Chapter 4

Comments and questions

Comments by Sheon

Figure 1.5. To reach 10 dB of squeezing the normalized pump power x must be at least 0.5

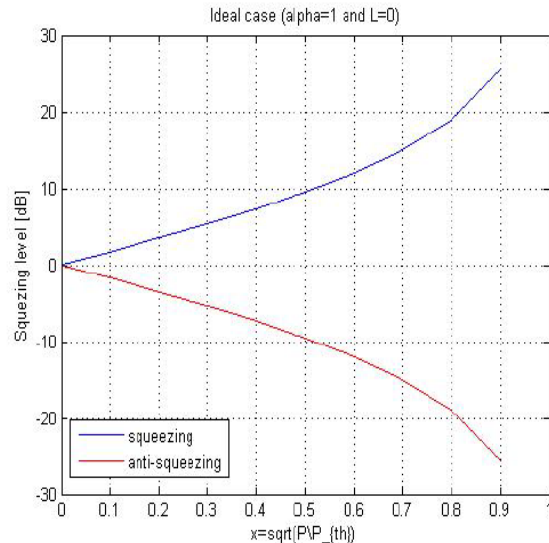
* **What's P/P_{th} ? Why is $x = 0.8$ the best and not $x = 0.5$?**

Can you verify if my analysis is correct? if so, I can re-add it in the chapter, maybe in a more synthetic way. Bachor says that $x=0.8$ is the maximum recommended value.

P/P_{th} is the ratio between the pump power and the threshold pump power. This ratio must be less than 1 (sub-threshold regime) to have squeezed vacuum. In the a previous version of the document I demonstrated that $x=0.5$ is the minimum value for x , in absence of losses (see attached document [pag.6, final part])

How said before, the amount of squeezing produced by the OPO depends on the threshold pump power. Considering an ideal case, ($\eta_{tot} = 1$ and $L = 0$) we can obtain an estimation of the lower limit value of the pump power with respect to the threshold power. As we can see in the figure (1.5), to reach 10 dB of squeezing the normalized pump power x must be at least 0.5. Then

Figure 1.8. In a realistic case, considering the maximum estimated value for the intra-cavity losses, the maximum achievable level of squeezing is equal to 10 dB, that correspond to our goal.

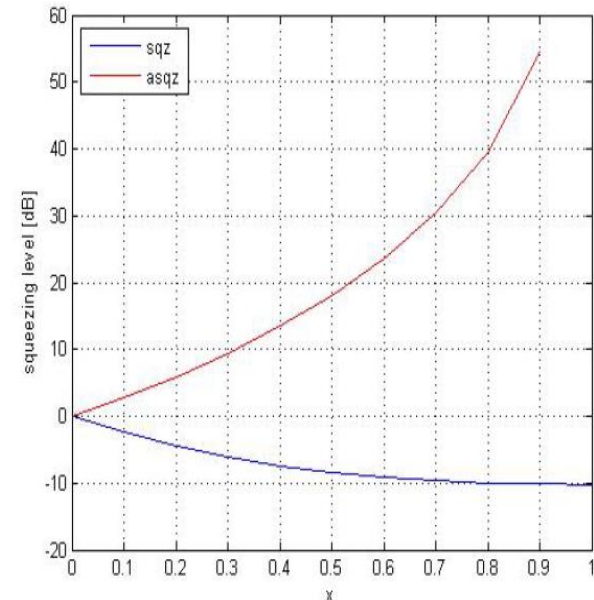
* 10 dB is the maximum? Why not more?

In a realistic case ($\eta_{prop} = 0.97$, $\eta_{q.e} = 0.94$, $\eta_{hom} = 0.98$)

It is the maximum, compatibly with our losses.
